PROJECT: C-8625 SR 520 West Approach Bridge North Project

SUBJECT: CO # 81 – Delete Facility M

**WASHINGTON STATE
DEPARTMENT OF TRANSPORTATION
CHANGE ORDER**

CO#81 - DELETE FACILITY M
STAGING ATTENUATOR RELOCATION

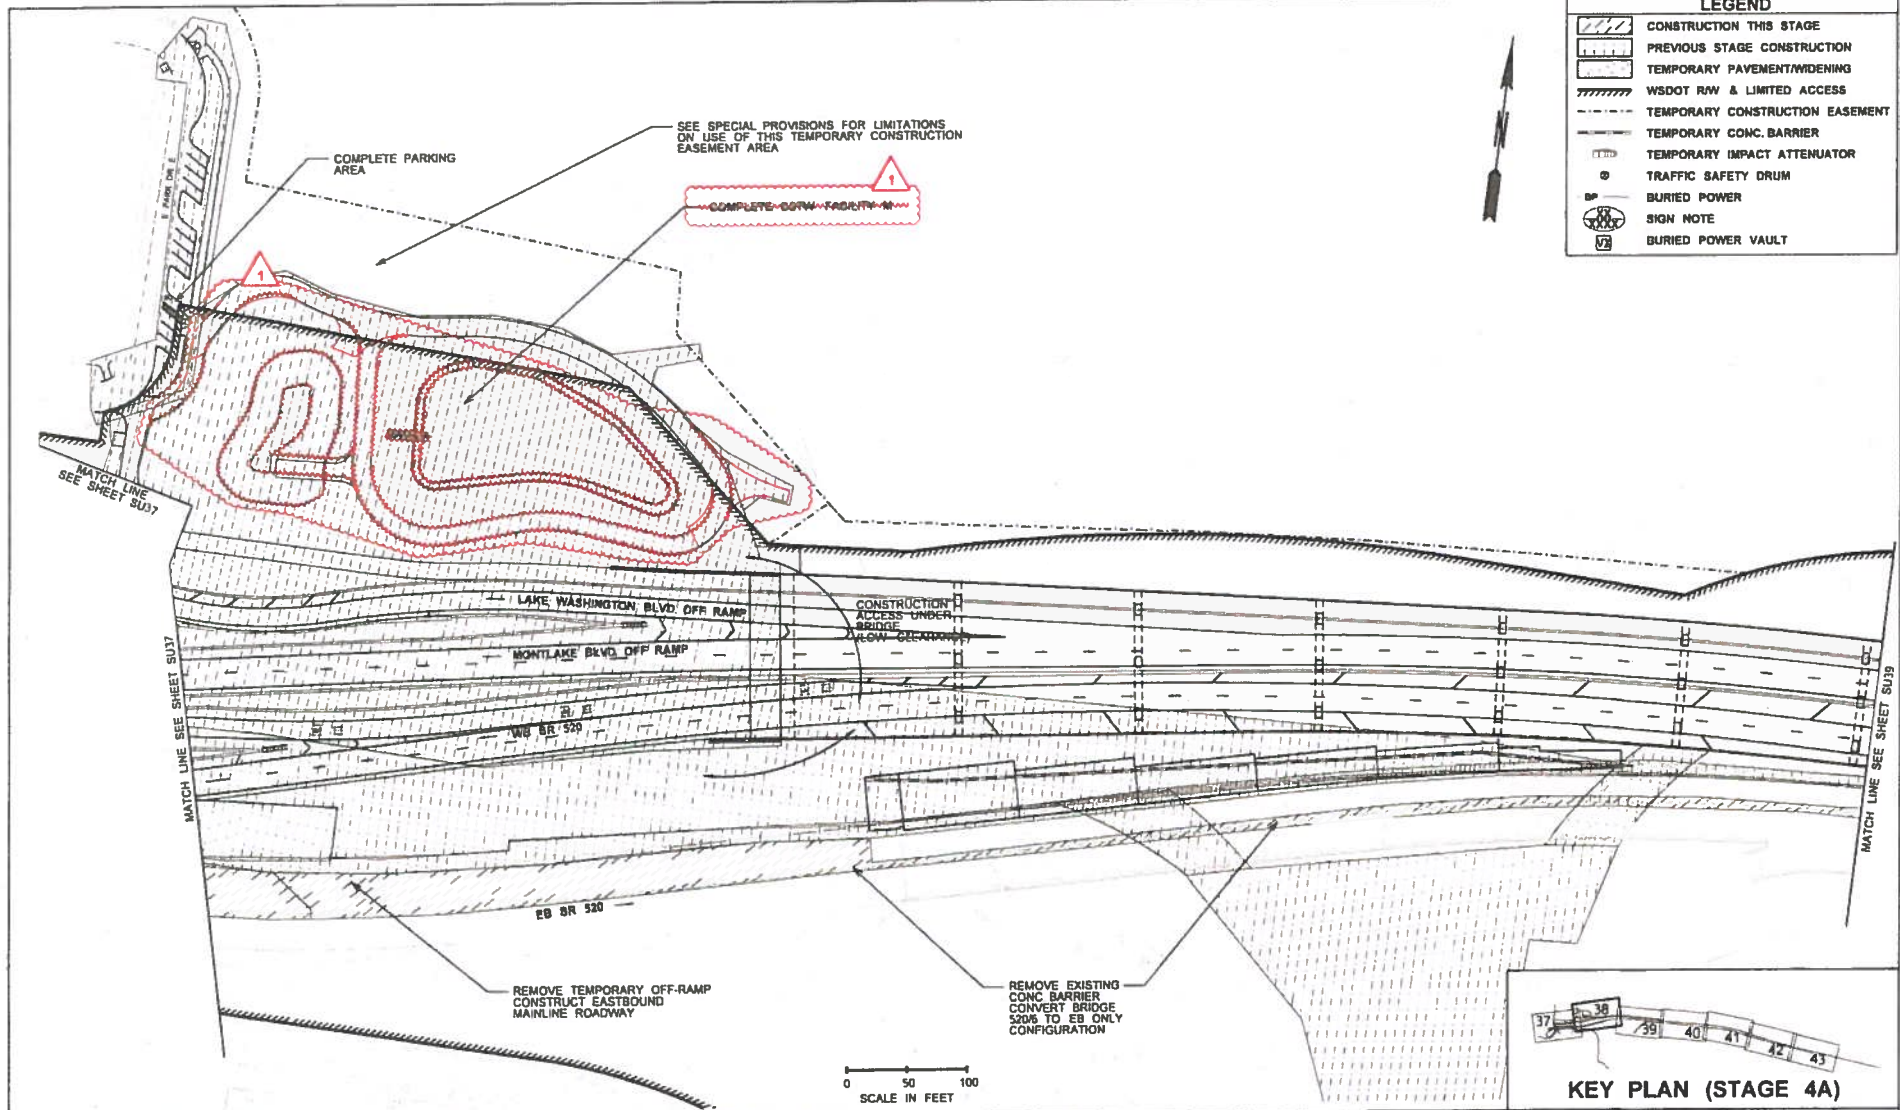
BRIDGE WIDENING FOR TEMPORARY OFFRAMP TO REMAIN. INSTALL BARRIER FOR EASTBOUND ONLY CONFIGURATION. SEE PAVING PLANS

FEDERAL AID PROJ. NO. 10 WASH JOB NUMBER 13A012 CONTRACT NO.	 HR ENGINEERING INC.	 DATE 3/6/16	 Washington State Department of Transportation	Contract 8625 Change Order 81 Page 14 of 72	PLAN REV. NO. SU38 SHEET 86 OF 1797 SHEETS
PARSONS BRINCKERHOFF			Parametrix	CONSTRUCTION STAGING PLAN

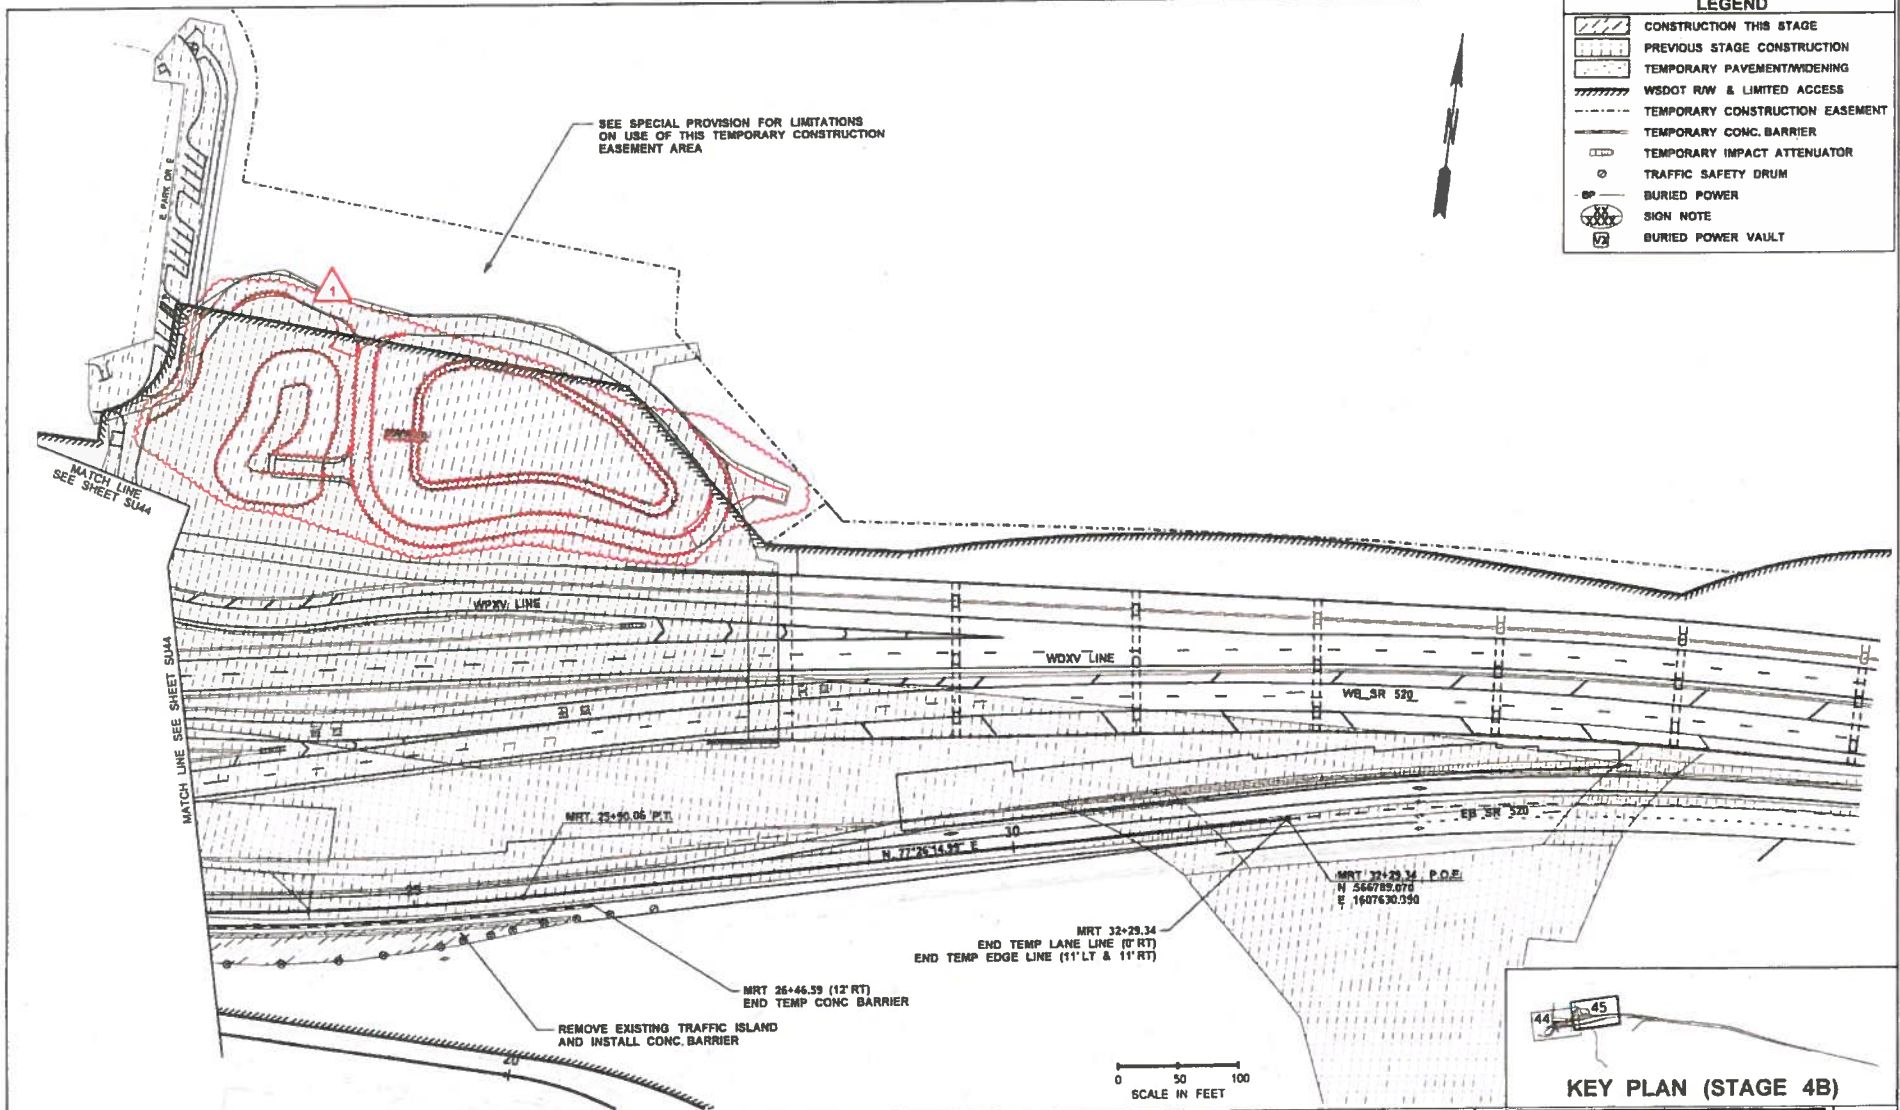
- RS05 and RS08 both titled "Roadway Sections"
- SU34, SU38 and SU45 all titled "Construction Staging Plan"
- SP01 and SP02 both titled "Site Preparation Plan"

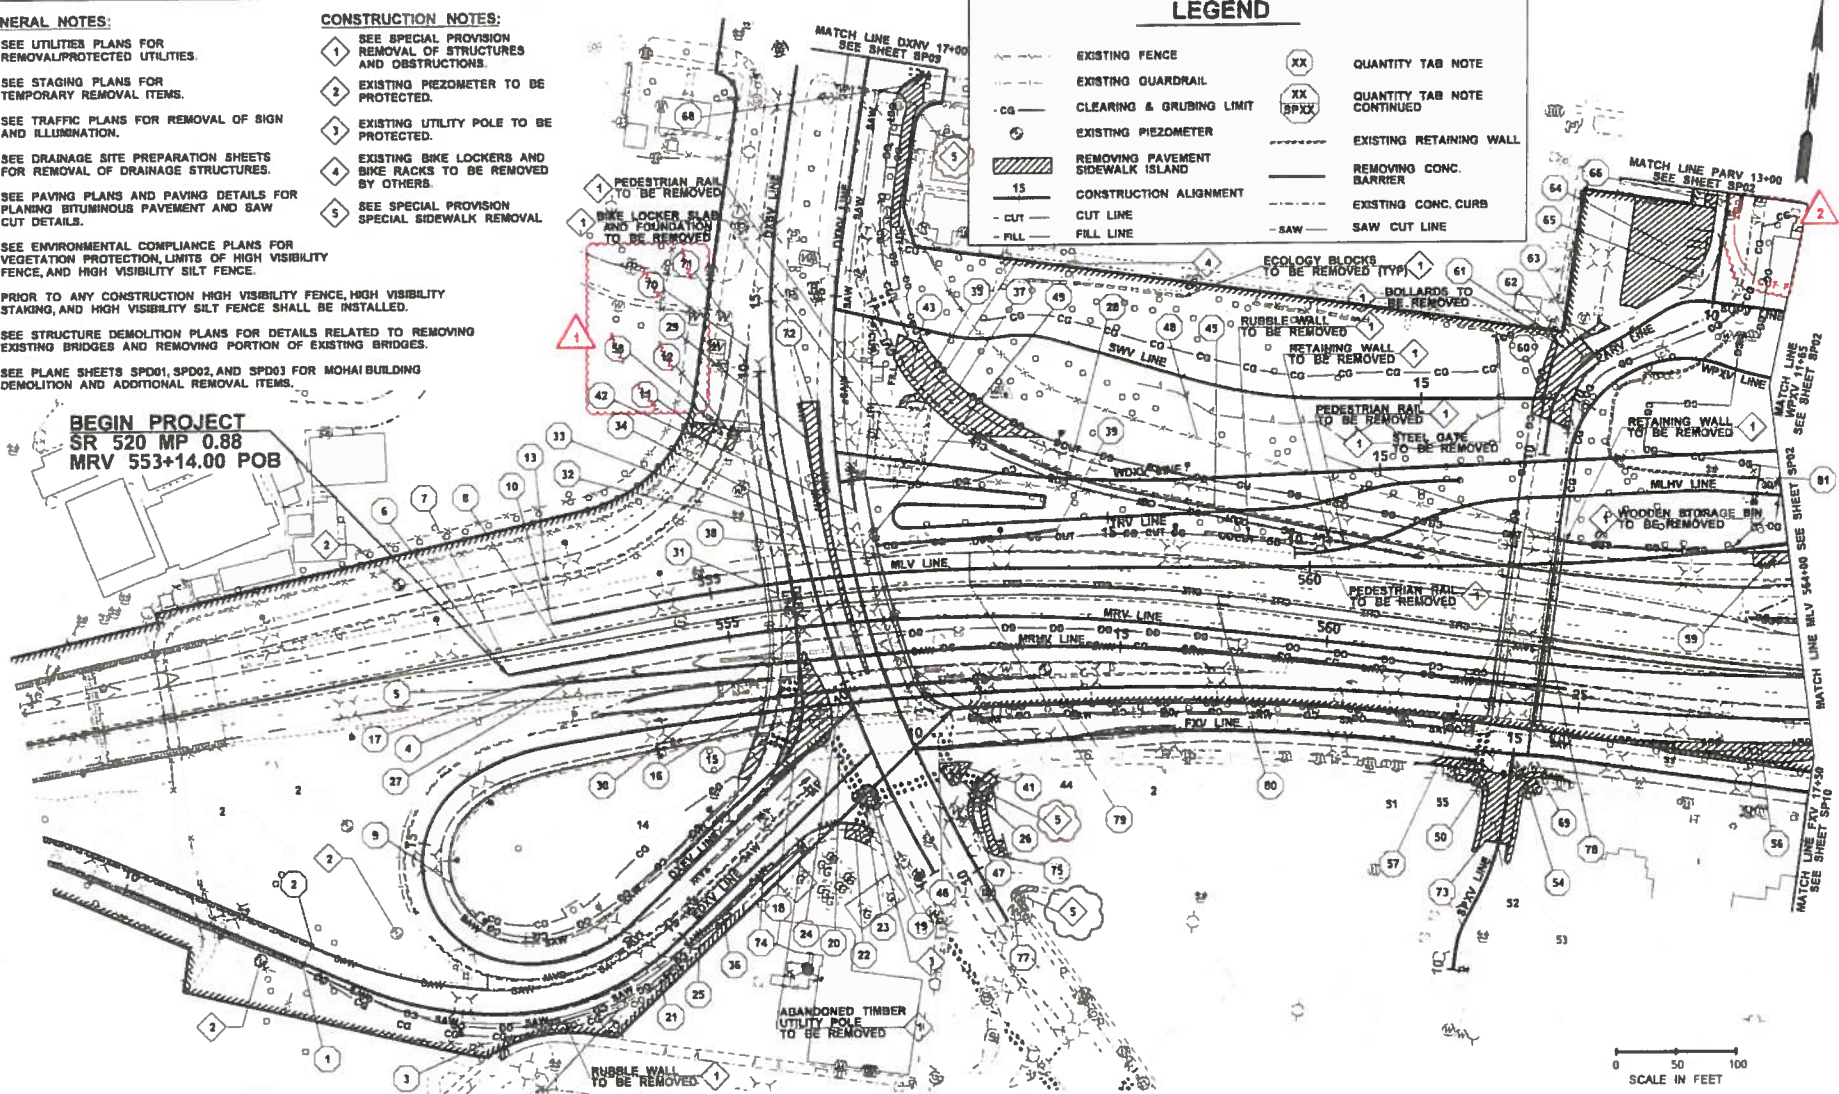
FILE NAME: PW\Program\Design-Bld-Build\Contract 008625 WABN02.0 Contract Documents\0.05 Contract Plans\0.05.02 As-Built\As-Built DGN\Fat01093 C8625 PB BU_45_R1.dgn		FED.AID PROJ.NO.				Washington State Department of Transportation	Contract 8625 Change Order 81 Page 15 of 72	PLAN REV. NO. SU45
TIME: 1:54:51 PM	DATE: 3/18/2016	REGION: 10	STATE: WASH					
PLOTTED BY: SancheA	DESIGNED BY: Y. CHANG	CHECKED BY: P. MERRELL	PROJ. ENGR.: D. EDWARDS	REGIONAL ADM.: J. MERREDITH	JOB NUMBER: 13A012	CONTRACT NO.	LOCATION NAME	DATE: 12/8/2015 BY: PW
REMOVE EXISTING TRAFFIC ISLAND AND INSTALL CONC. BARRIER		CO#81 - DELETE FACILITY M		REVISION		CONSTRUCTION STAGING PLAN

PLAN REF. NO.
SP02A

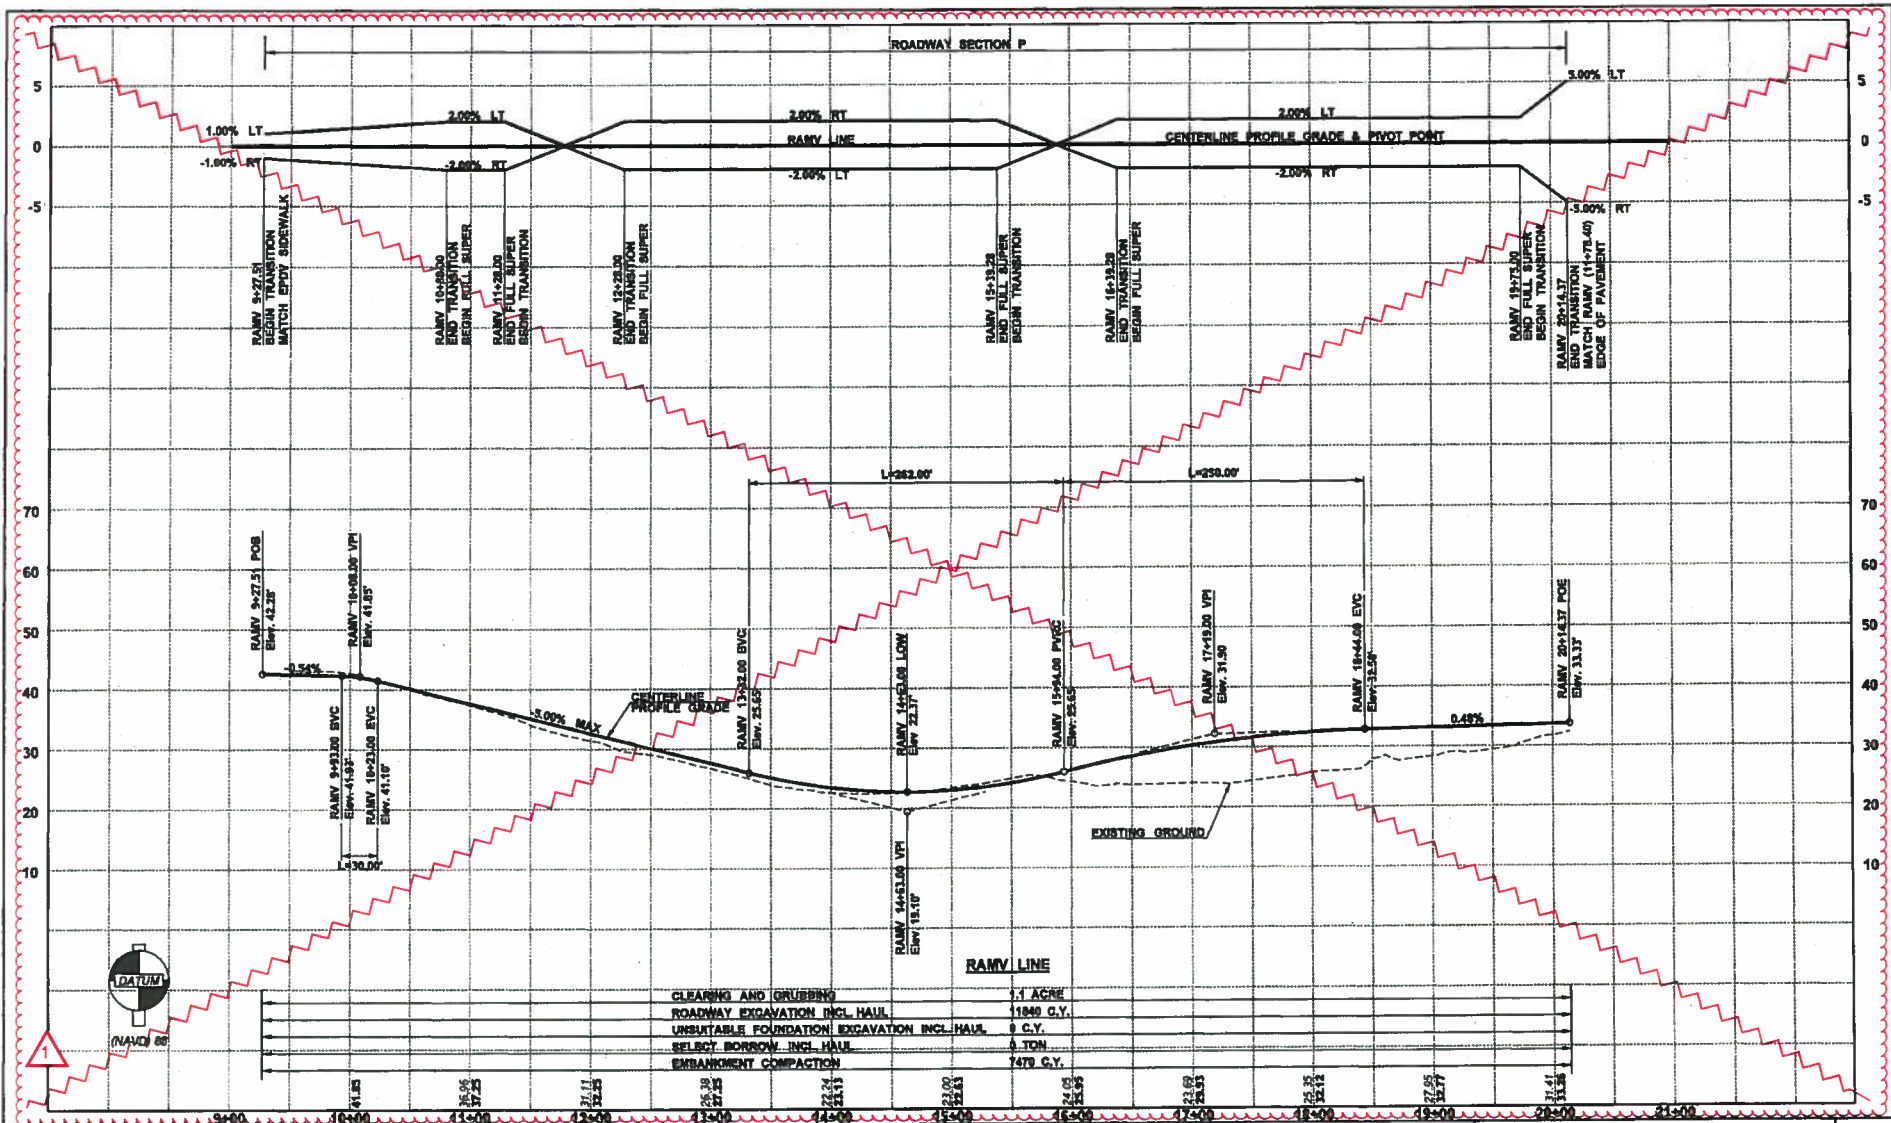
Add the following Plan Sheets included as pages 18 and 20 of this change order:

- SP02A titled "Site Preparation Plan".
- RP14A titled "Roadway Profile".

Contract 8625
Change Order 81
Page 60 of 72
WALL 9 LAYOUT

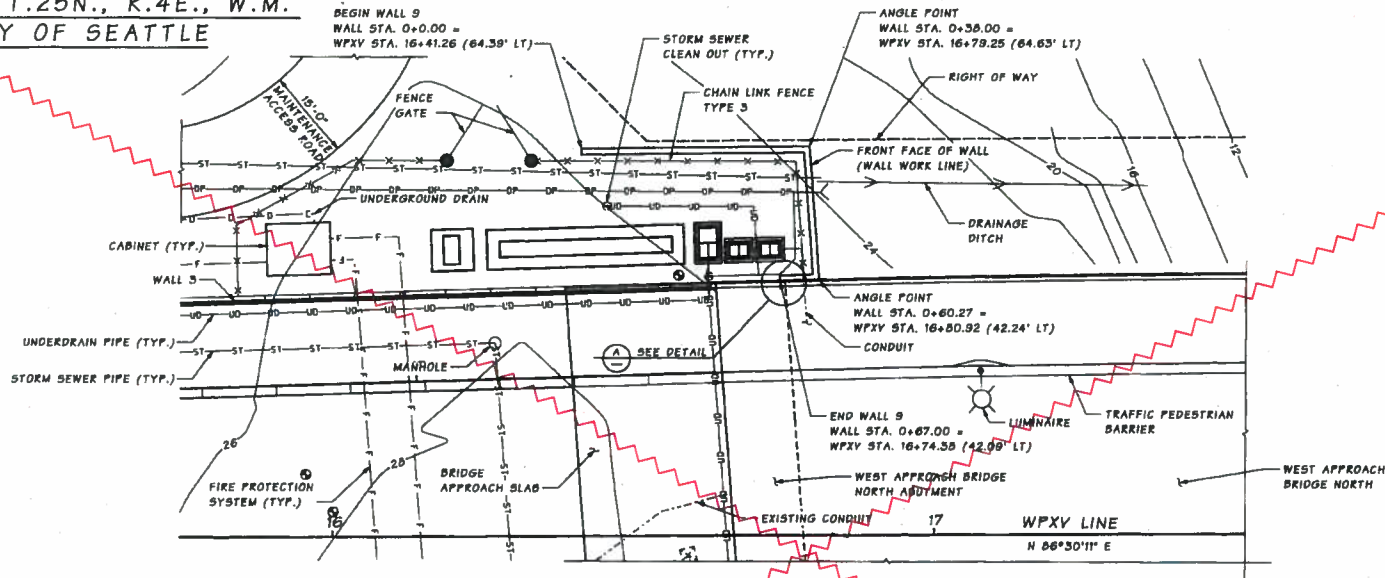
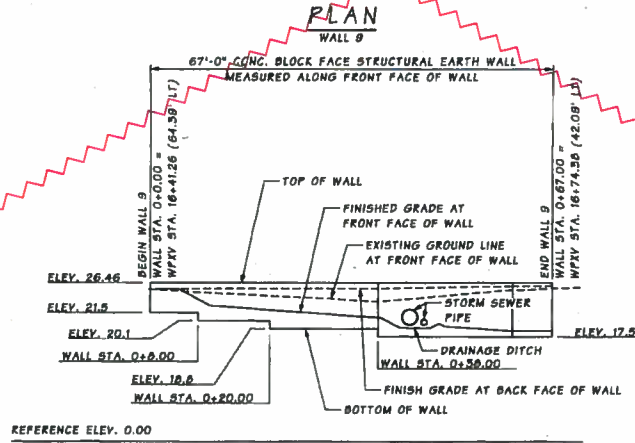
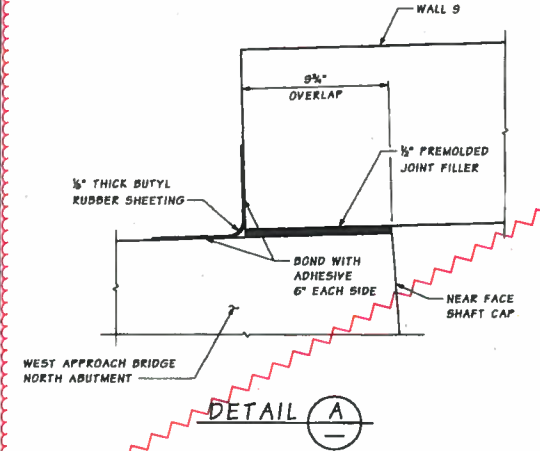
3. As a result of the deletion of the CSTW, other modifications being made to Pier 1 in Change Order 103, and construction staging for future projects, Retaining Wall 9 no longer needs to be constructed. That wall is deleted from the Contract in this change order.

This change order also eliminates Wall 9 and the scupper blocks for concrete barriers on WAEN.
